Medworth Energy from Waste Combined Heat and Power Facility

PINS ref. EN010110
Document Reference Vol.10.2
Revision: 1.0
Deadline: 2
March 2023

Applicant's response to the ExA's Written Questions (ExQ1)

Figure 2.1: Human receptors in an AQMA

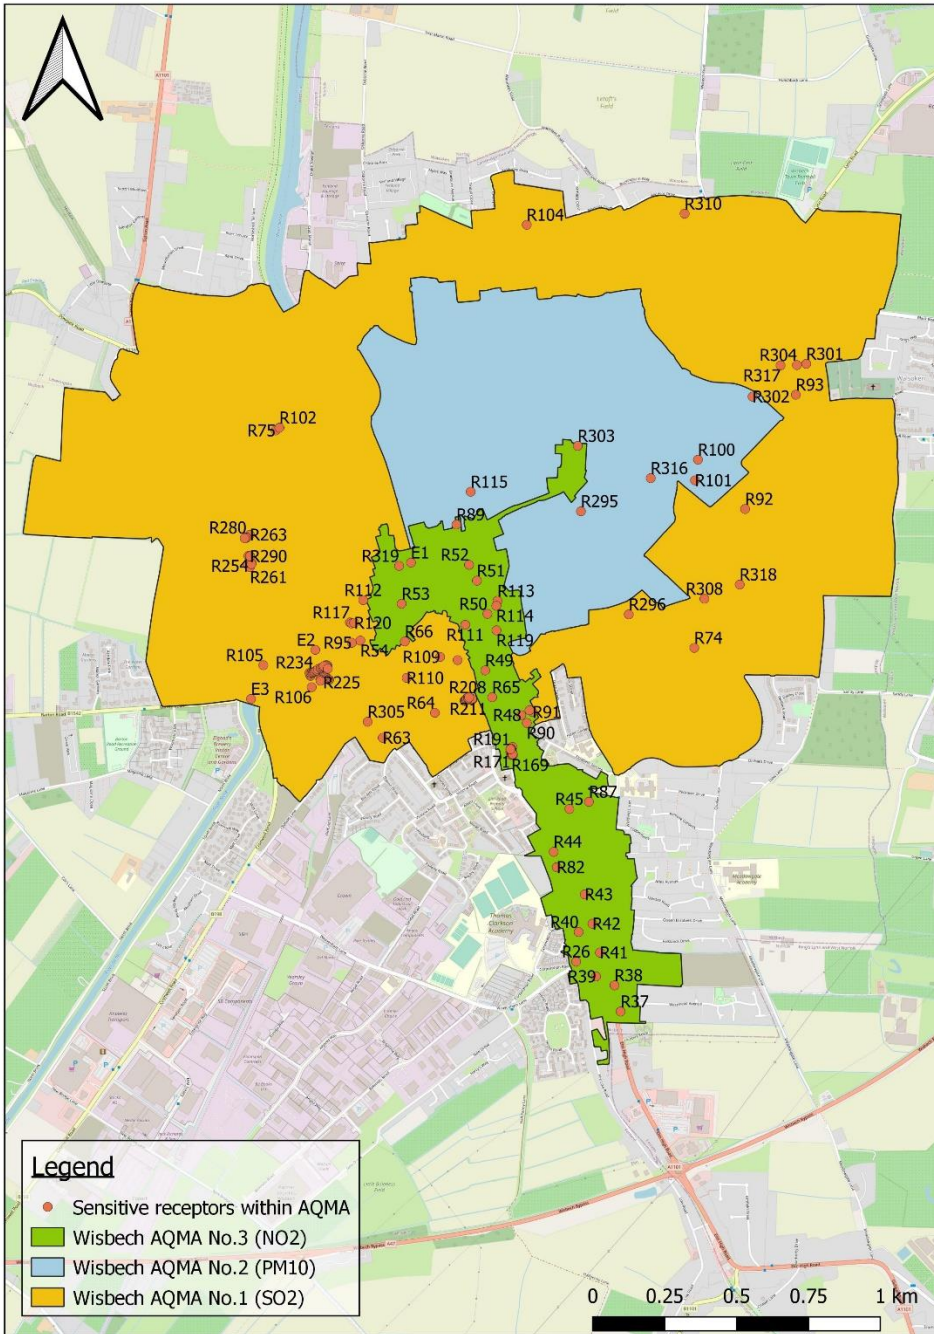
AQHH.1.9	Applicant	Annex C Modelled Receptors of the ES Chapter 8 Air Quality Appendices [APP-078] provides a list of receptors and their addresses, however it does not show which are included within a AQMA. Can the Applicant provide a list of receptors which are located within an AQMA and a summary of how the Proposed Development is anticipated to affect these receptors, both during construction and operation?	<p>A list of receptors which are located within an AQMA are presented in Appendix 10.2E of the Applicant's response to the ExA's Written Questions (ExQ1) – Appendices (Volume 10.2) submitted at Deadline 2.</p> <p>Results for the construction phase assessment are reported in Table 8B.H1, Annex H of Revision 3 of the Air Quality Appendix 8B (Volume 6.4) submitted at Deadline 2. The results show negligible impacts at each sensitive receptor.</p>

2.1.2 **Figure 2.1** presents these human receptors and the AQMAs on a map and **Table 2.1** below reports the human receptors found in these AQMAs.

Figure 3.14
Outline Landscape and Ecology Strategy

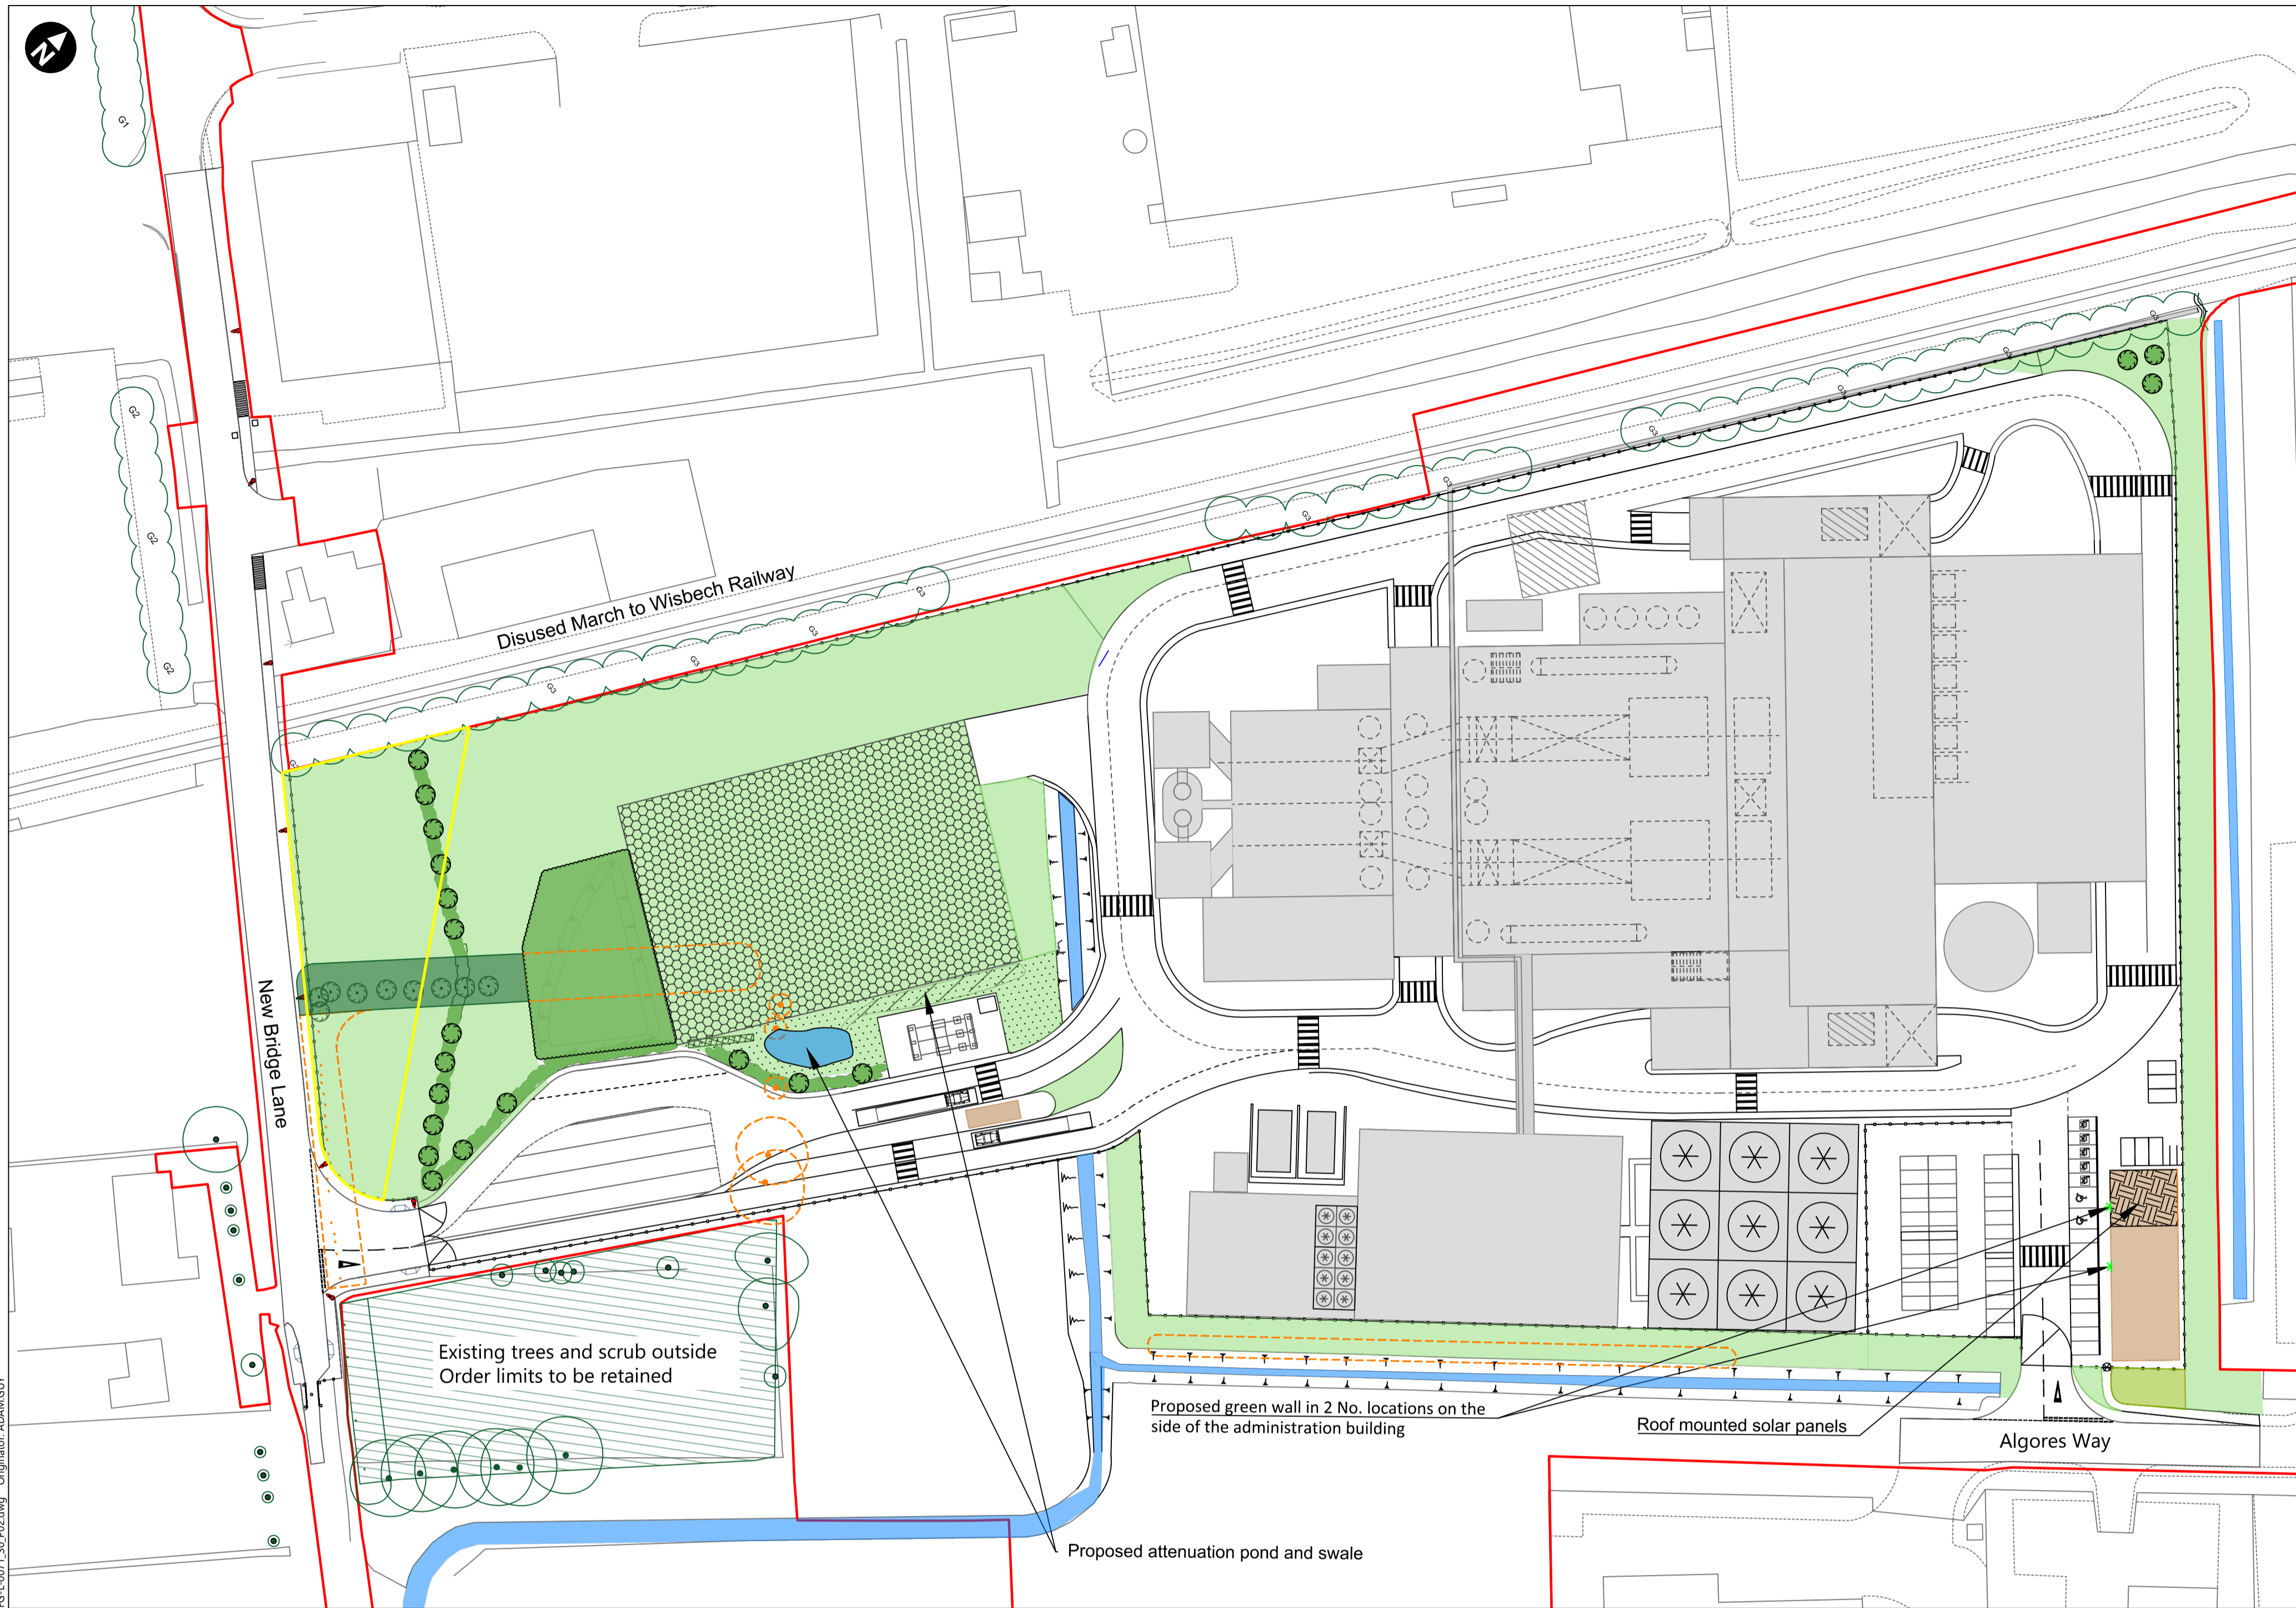
ExQ1	Question to	Question	Applicant Response
		<p>Landscape and Ecology Strategy are excluded from any BNG calculations?</p> <p>3) Can the Applicant update Figure 3.14 Outline Landscape and Ecology Strategy [APP- 030] in order to show the location and extension of the area of landscaping in the southern part of the EfW CHP Facility Site, alongside New Bridge Lane, that is reserved to accommodate a potential new bridge embankment?</p>	
BIO.1.4	Applicant	<p>The NPS for energy aim to minimise the impact of energy on the environment and promote sustainable development. Can the Applicant please expand on how it has aimed to minimise the impact of the proposal on the natural environment?</p>	<p>The Applicant's consideration of the NPS for energy is set out in the Planning Statement (Volume 7.1) [APP-091] and the National Policy Statement Tracker (Volume 9.18) [REP1-052].</p> <p>The Applicant has appointed suitably experienced ecologists to undertake biodiversity baseline surveys and Ecological Impact Assessment of the Proposed Development, following good practice methodologies as set out in ES Chapter 11 Biodiversity (Volume 6.2) [AS-008]. The Proposed Development avoids directly or indirectly affecting international/national/local nature conservation sites. There has been ecological input to the design of the Proposed Development which sought to avoid or minimise impacts on important ecological features, such as locating the Grid Connection within New Bridge Lane and Broadend Road and within the verge of the A47 (see Section 2.7 of ES Chapter 2 Alternatives (Volume 6.2) [APP-029]).</p> <p>Table 11.16 of ES Chapter 11 Biodiversity (Volume 6.2) [AS-008] summarises the environmental measures and feature-specific measures that have been embedded into the Proposed Development which would be implemented to avoid or minimise impacts on biodiversity. These measures are included in the Outline Construction Environmental Management Plan (CEMP) (Rev 2) [REP1-024] and accompanying Appendix D Outline Ecological Mitigation Strategy and the Outline Landscape and Ecology</p>

ExQ1	Question to Question	Applicant Response
		<p>Management Plan [APP-098], which are secured by Requirement 10 and Requirement 5 respectively in Draft DCO (Volume 3.1) [REP1-007].</p> <p>The Applicant is committed to delivering Biodiversity Net Gain for the Proposed Development, as outlined in Additional Submission – 6.4 Environmental Statement Chapter 11 Biodiversity Appendix 11M Biodiversity Net Gain - Rev 2 [AS-009].</p> <p>Section 11.10 of ES Chapter 11 Biodiversity (Volume 6.2) [AS-008] outlines biodiversity enhancements that would be provided by the Proposed Development. An Outline Landscape and Ecology Strategy ES Figure 3.14 (Volume 6.3) updated at Deadline 2 has been developed to provide habitat retention and creation within the EfW CHP Facility Site. This strategy is secured in Requirement 4 of the Draft DCO (Volume 3.1) [REP1-007]. This strategy aligns with local habitat creation priorities identified in accordance with habitat Opportunity Mapping by the Cambridgeshire & Peterborough Environmental Records Centre and has been designed to extend habitat and connectivity for species and habitats present in the locality. In addition to habitat provisions, the Proposed Development would provide a range of other biodiversity provisions as outlined within Section 11.10.5 of ES Chapter 11 Biodiversity (Volume 6.2) [AS-008] to provide sustainable benefits to species and the natural environment, such as the provision of nesting/roosting features, planting of native species which would be of local provenance wherever possible, and using site-won materials where possible during habitat creation to minimise the requirement for importing virgin materials. These measures are included in the Outline Landscape and Ecology Management Plan (Volume 7.7) [APP-098], which is secured by Requirement 5 of the Draft DCO (Volume 3.1) [REP1-007].</p> <p>In addition, the Applicant proposes to create brown roofs on the Administration Building and Weighbridge and include a green wall on the Administration Building also. The location and extent of the brown roof and green wall can be seen on ES Chapter 3 Description of the Proposed Development Figure 3.26 Administration building elevations (Volume 6.3) [APP-049].</p>
